Subject: **ADDENDUM NO. 7**

Project: **CENTER FOR MATERIALS AND MANUFACTURING SCIENCES, TROY UNIVERSITY MAIN CAMPUS-TROY ALABAMA**

Job #: **SSL# 18144**
BC# 2020416
PSCA#: 006P

Sheet Number
A9.4

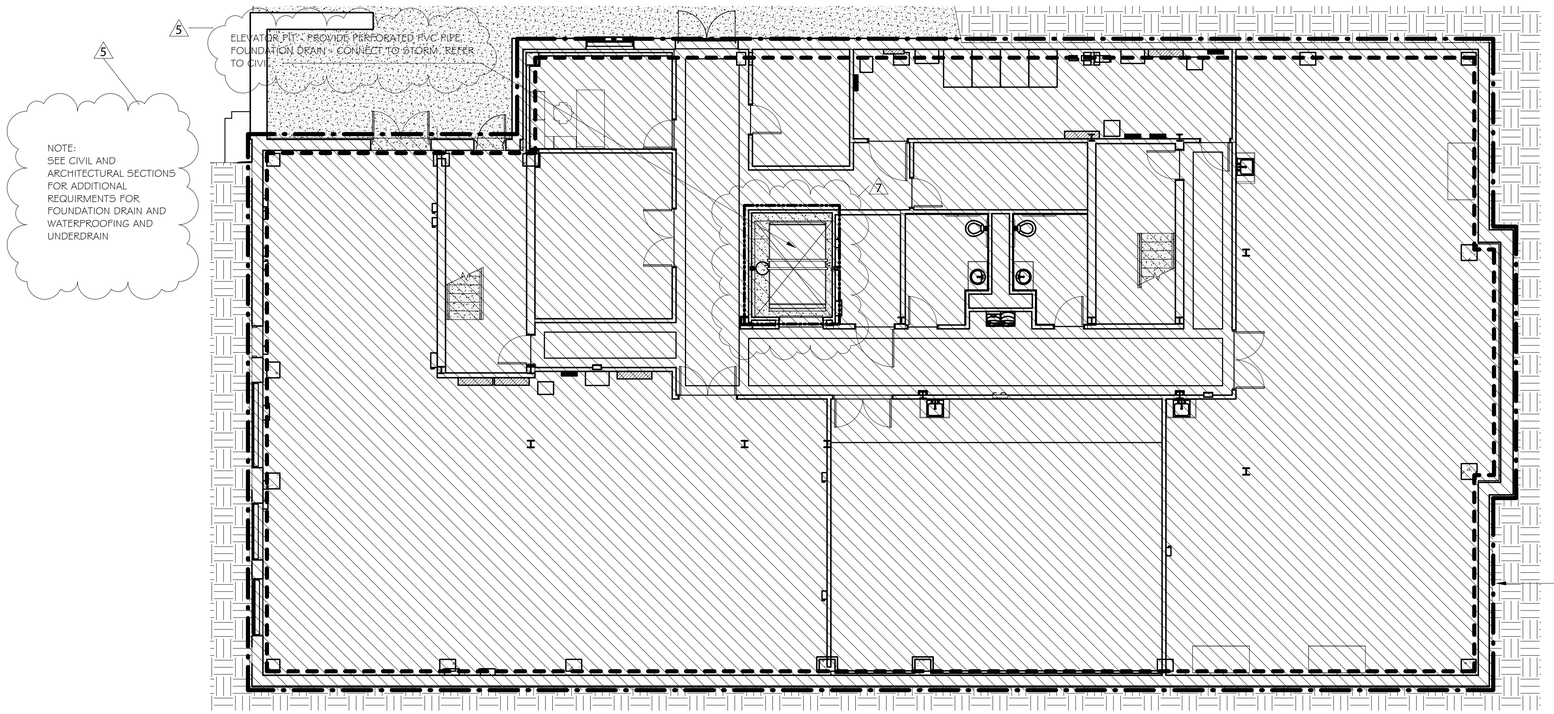
Item 12: Replace A9.4 with the attached A9.4:
-Revise Waterproofing legend & diagram

Job Number: 18144
Date: 11/17/2020
Drawn By: CS,JB,DB,LG
Checked By: JS, FL
Project Title: CENTER FOR MATERIALS AND MANUFACTURING SCIENCES
TROY UNIVERSITY | TROY, AL
Sheet Title: FURNITURE, FIXTURES & EQUIPMENT PLANS
Sheet Number: A10.0

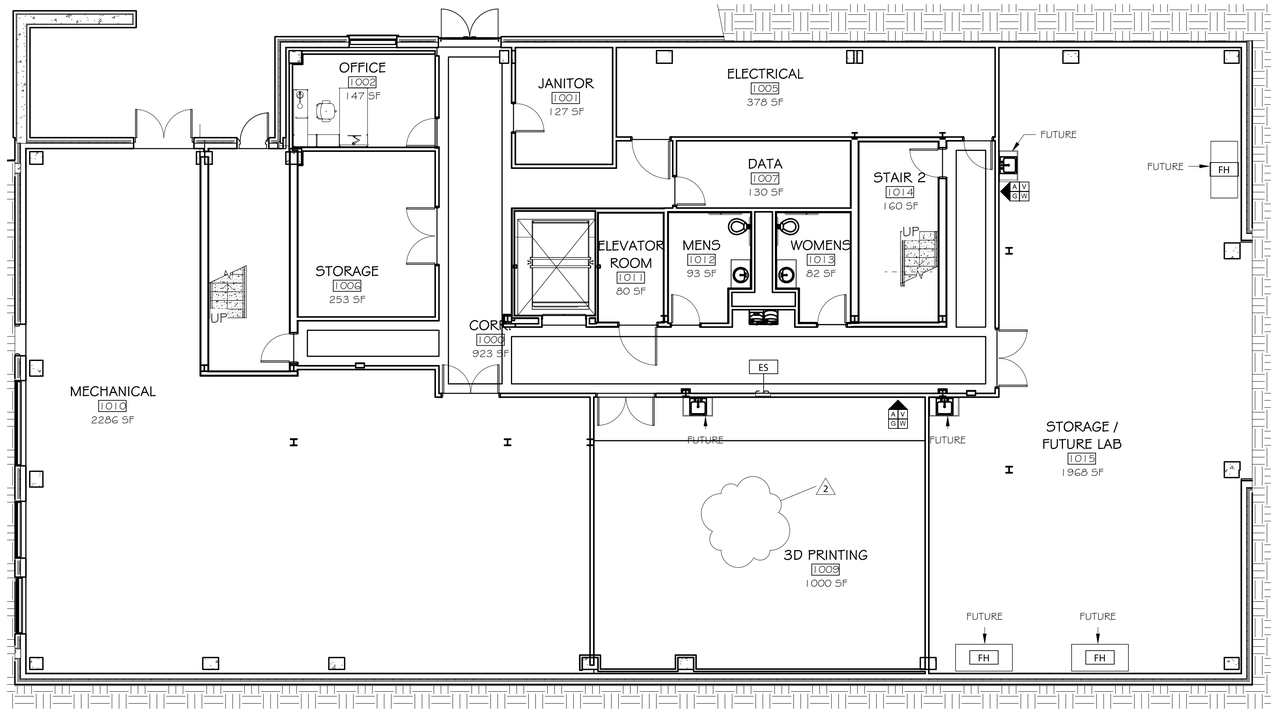
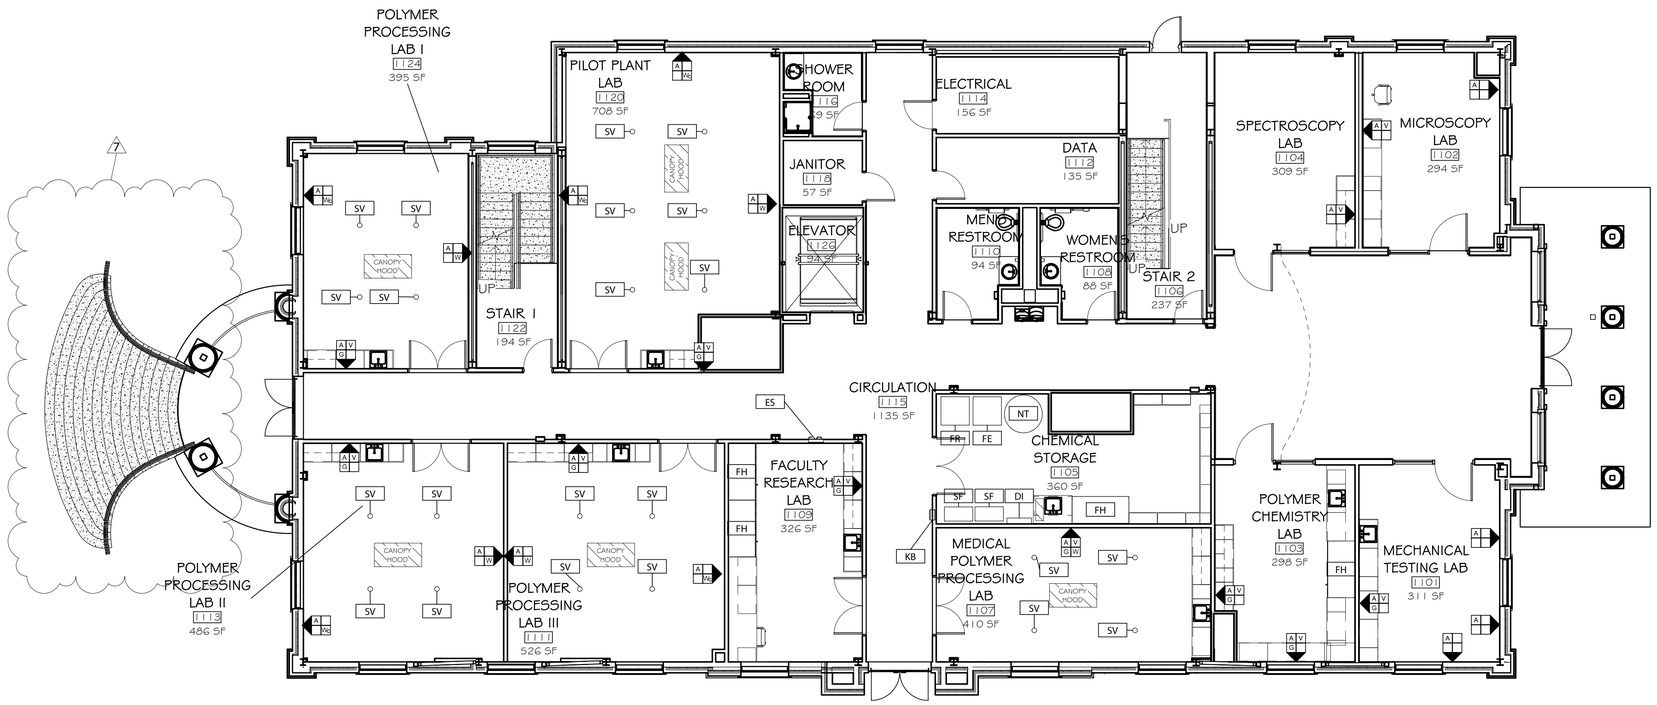
Item 13: Replace A10.0 with the attached A10.0:
-Revise West stair footprint

E001

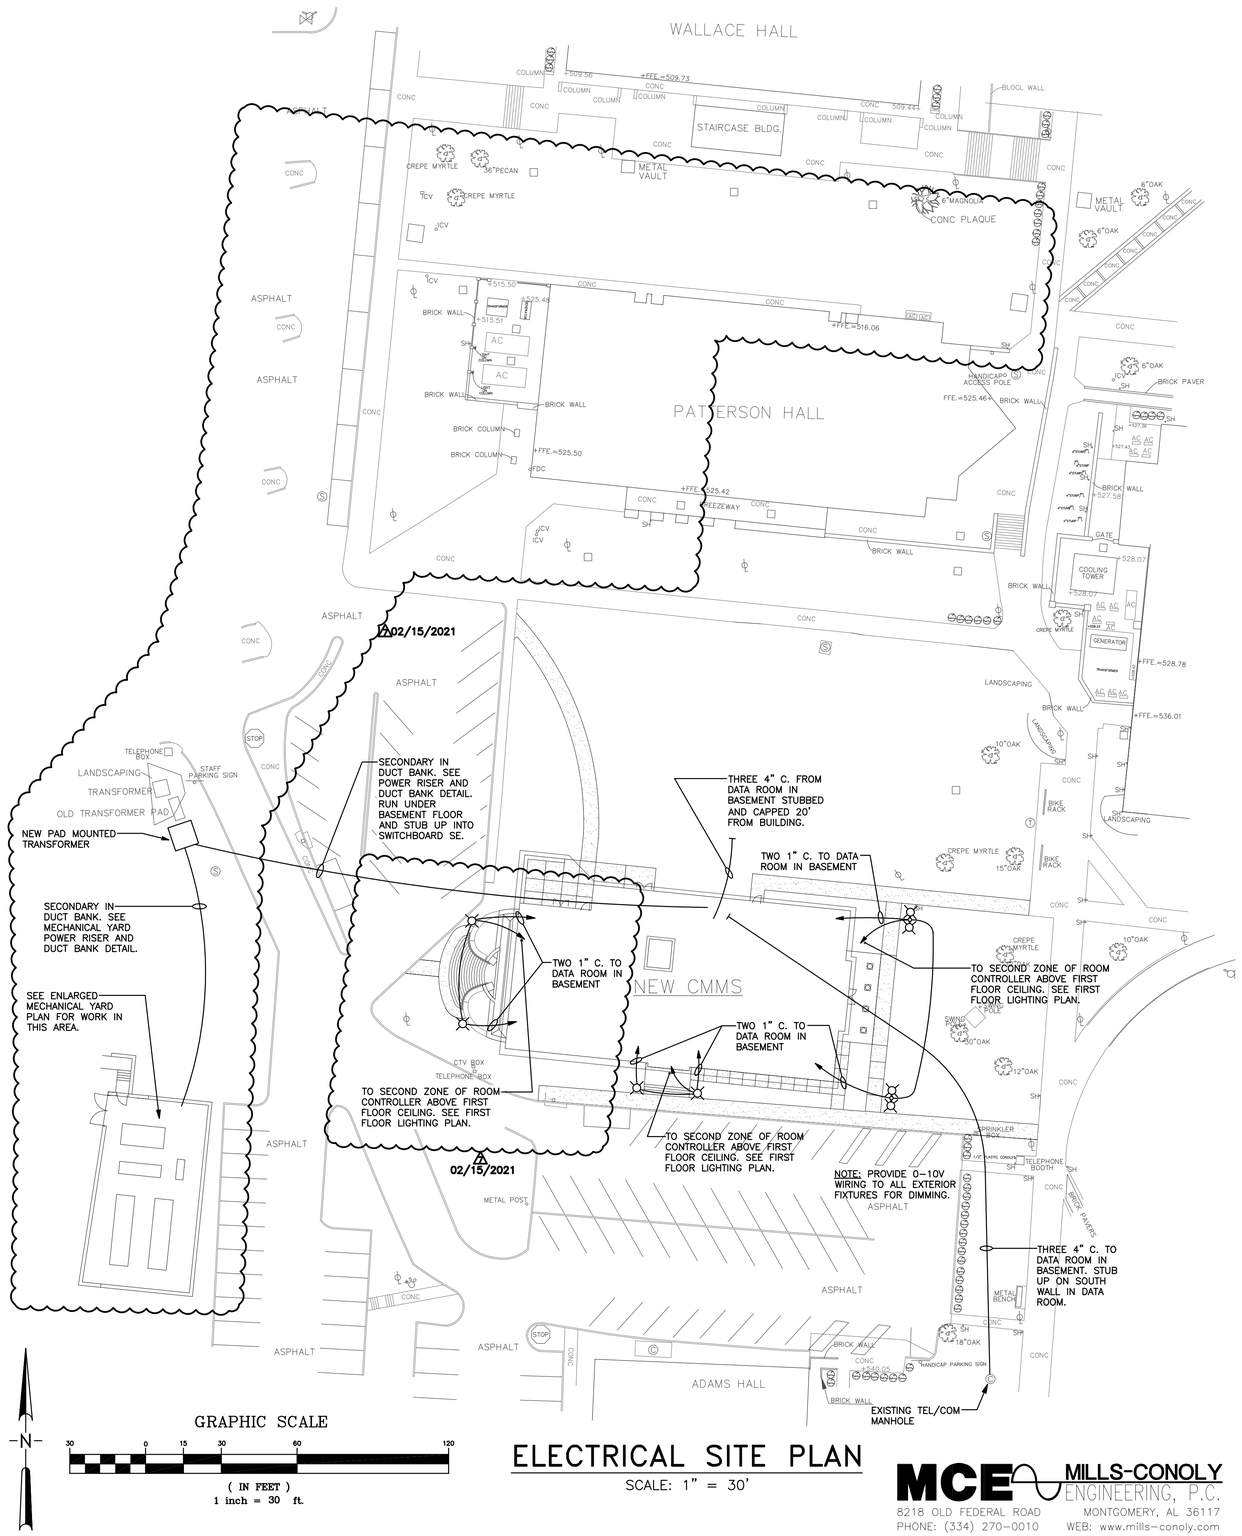
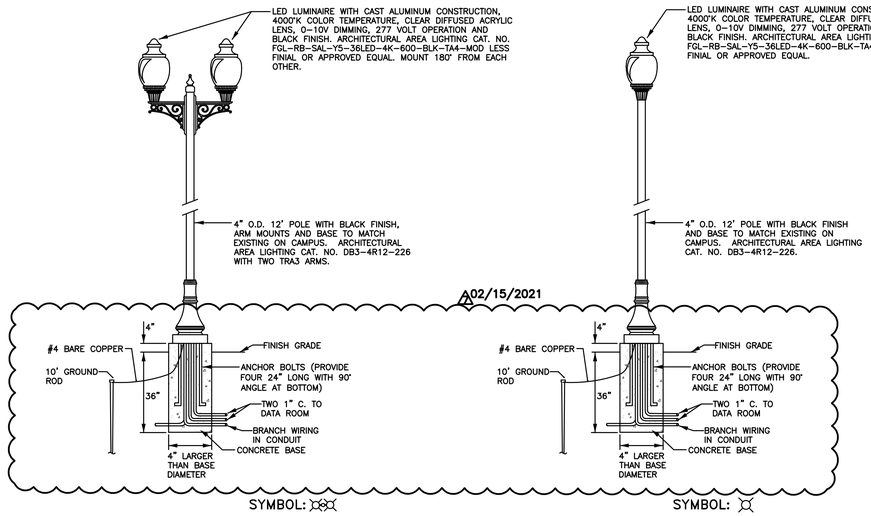
Item 14: Refer to attached sheet E001:
-Removed primary electrical relocation and work
-Moved mechanical yard and equipment
-Combined building and mechanical yard transformers into one
-Added acorn pole mounted lights to west stairs
-Added data conduits to lighting standard details
-Moved VRF-1A&B to mechanical yard

Job Number: 18144
Date: 11/17/2020
Drawn By: SCC
Checked By: SLC
Revised: 02/15/2021
Project Title: Center for Materials and Manufacturing Sciences, TROY UNIVERSITY
Sheet Title: Mechanical Yard Electrical Site Plan
Sheet Number: E002

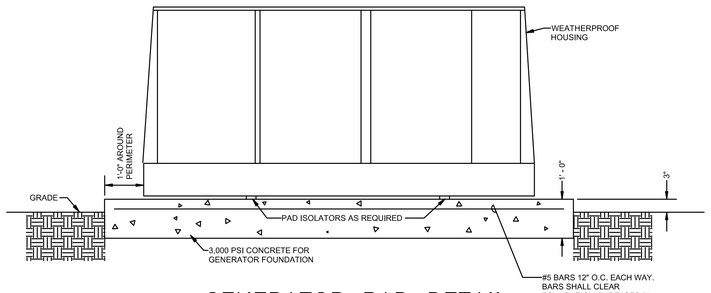
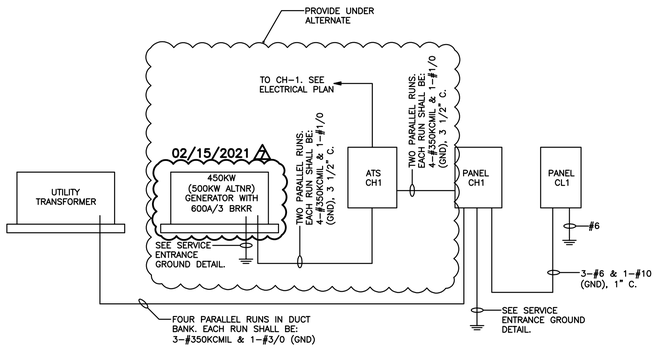
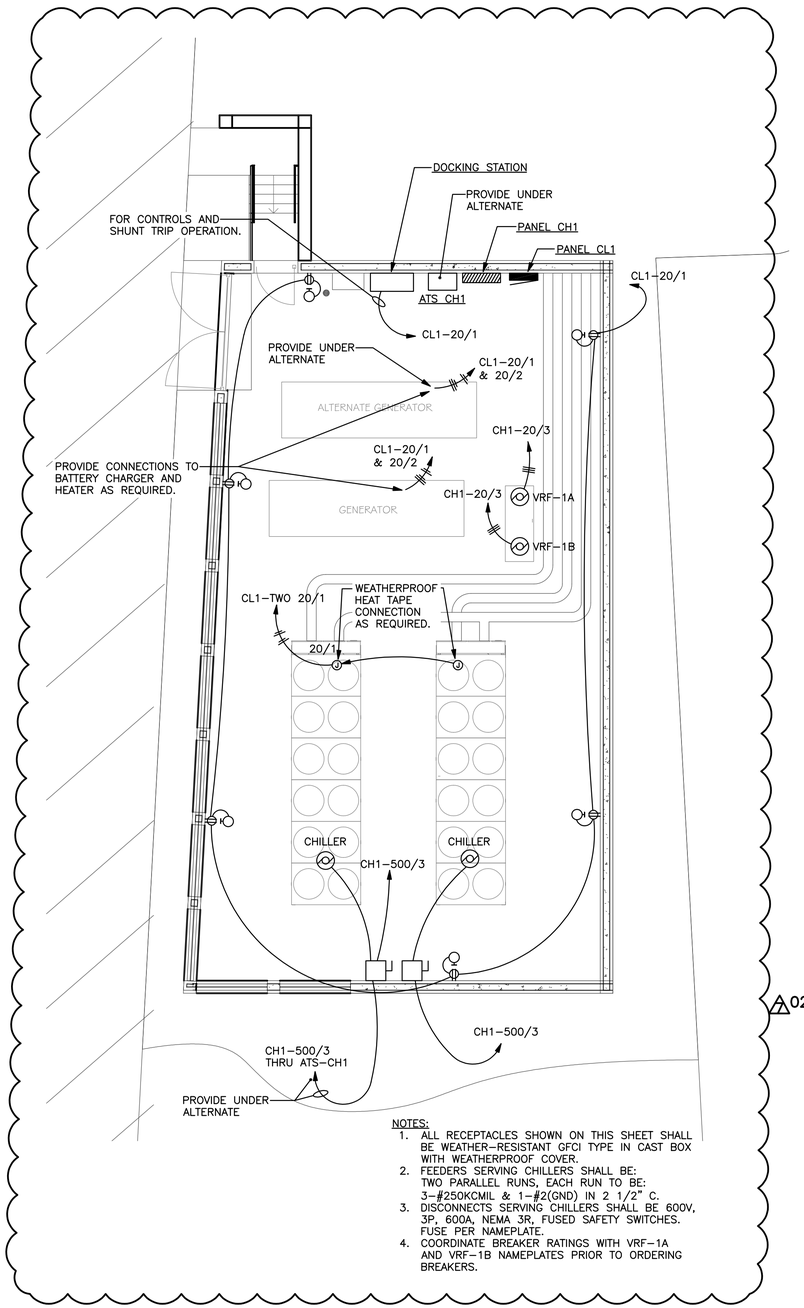
Item 15: Refer to attached sheet E002:
-Revised docking station detail
-Changed generator descriptions on riser diagrams
-New mechanical yard layout
